Project : East Malling Trust Sites B & C, Ditton

Report Title : Technical Note – Response to KCC Comments

Report Ref : 182600-17

Drawing Title  
**POTENTIAL IMPROVEMENTS AT A20 /  
NEW ROAD / HOTEL JUNCTION**

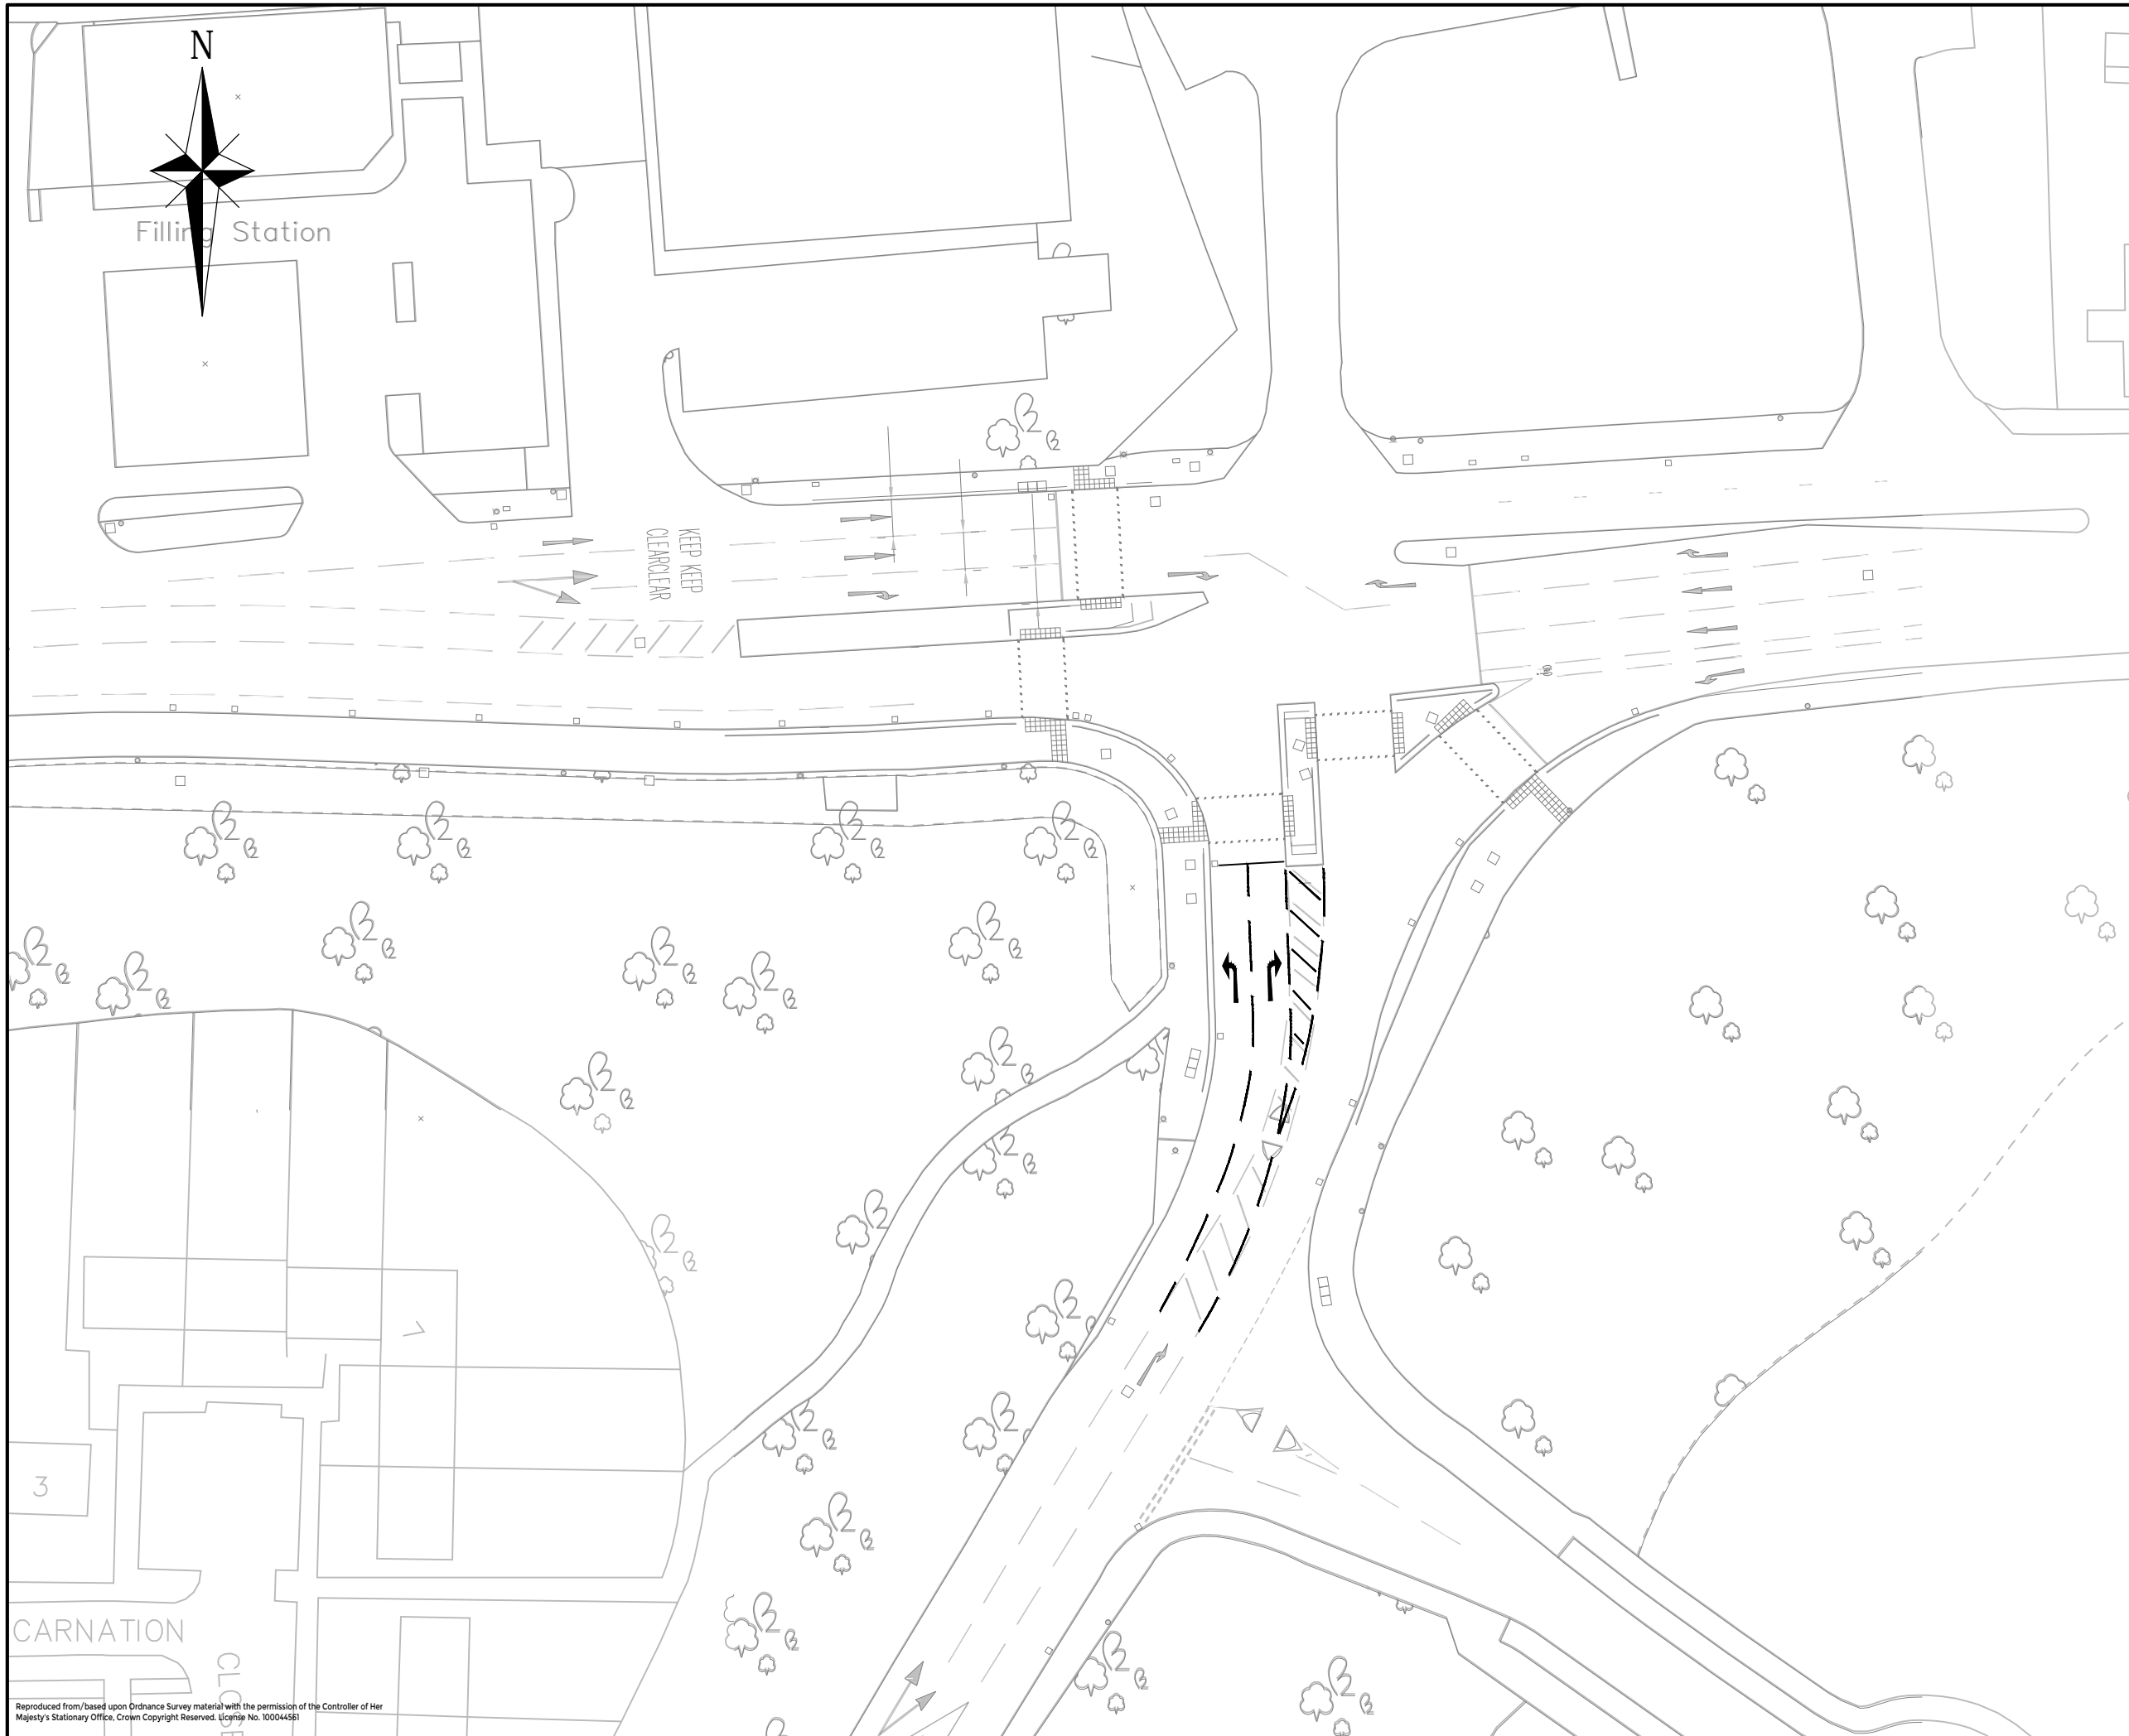
With regard to this application, Site B, I note Drawing Number 182600-008, improvements at A20/New Road/Hotel Junction and the discussions of the junction given in the TA through paragraphs 6.19 to 6.21. From this discussion the applicant's intentions to establish these improvements, in a timely way to the development of Site B, is not clear.

- 2.34 The above tables also include results for two potential improvements schemes **at each junction. The 'KCC improvements' reflect the potential improvements shown in Drawing Number 182600-016 for the A20/New Road/Hotel junction and Drawing Number 182600-017 for the A20/Station Road/New Road junction.** These comprise significant improvement designs that are consistent with improvements being highlighted by KCC as part of their proposed infrastructure to support the Local Plan. **The 'Ardent improvements' results reflect improvement proposals for these junctions that were previously offered within the Transport Assessments submitted with the planning applications, as shown in Drawing Numbers 182600-007 and 182600-008.**
